**TP199344 MODIFICATION KIT**  
**AND TP117176 FUSE**

*APPARATUS AFFECTED:* 35A and 35B Call Control Units.

*OBJECT:* To prevent grounding the transistor case, and to provide delayed-action-type fuses.

Fig. 1

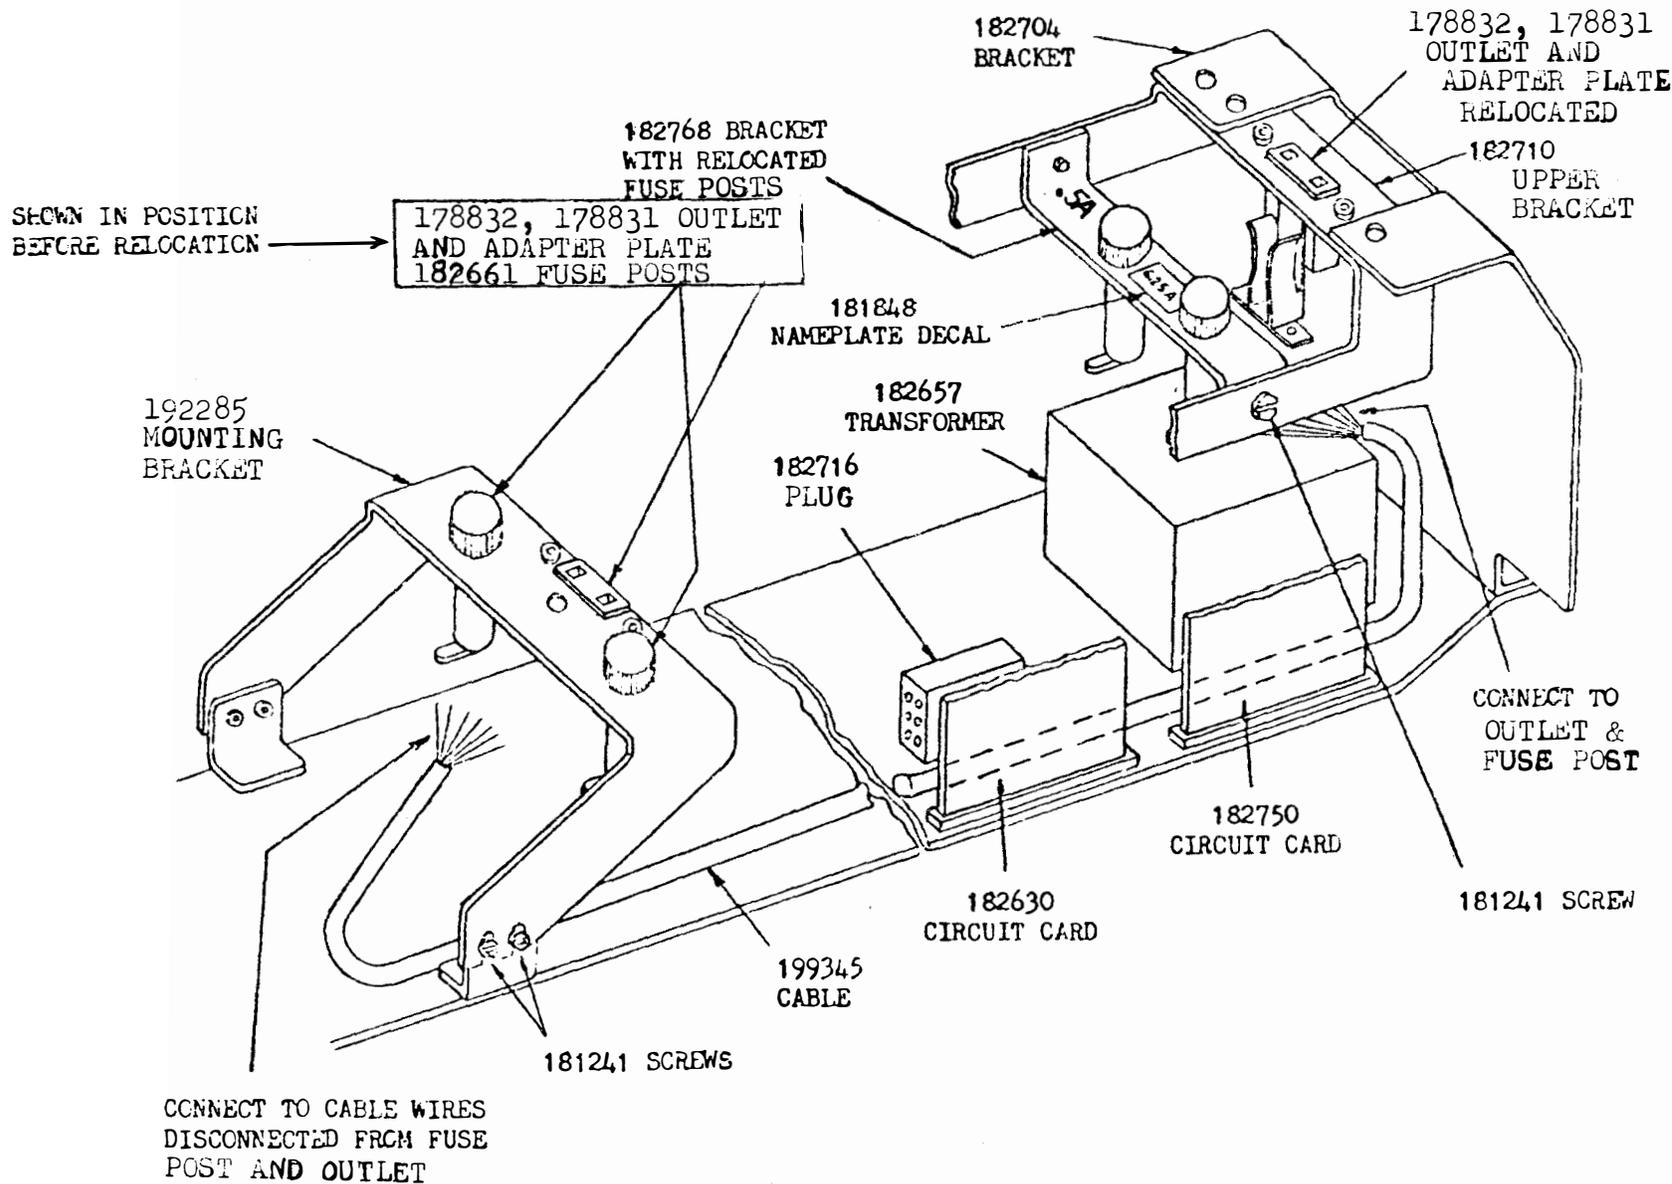
- (b) The TP178831 outlet and the TP178832 adapter plate are removed from the TP192285 mounting bracket and are now mounted on the TP182710 upper bracket. (See Fig. 1.)

- (c) A new TP182768 bracket is mounted between the sides of the TP182710 upper bracket. (See Fig. 1.)
- (d) The two TP182661 fuse posts are removed from the TP192285 mounting bracket and are now mounted on the TP182768 bracket. (See Fig. 1.)

- (e) The TP192285 mounting bracket is removed and discarded.
- (f) A TP181848 fuse-identification plate (6.25A) is added to the TP182768 bracket, between the two TP182661 fuse posts. (See Fig. 1.)

- (g) A fuse-rating designation (.5A) is stamped on the TP182768 bracket, adjacent to the TP117176 fuse. (See Fig. 1.)
- (h) A power-rating designation (100 WATTS MAX) is stamped on the TP182710 bracket, adjacent to the TP178831 outlet.
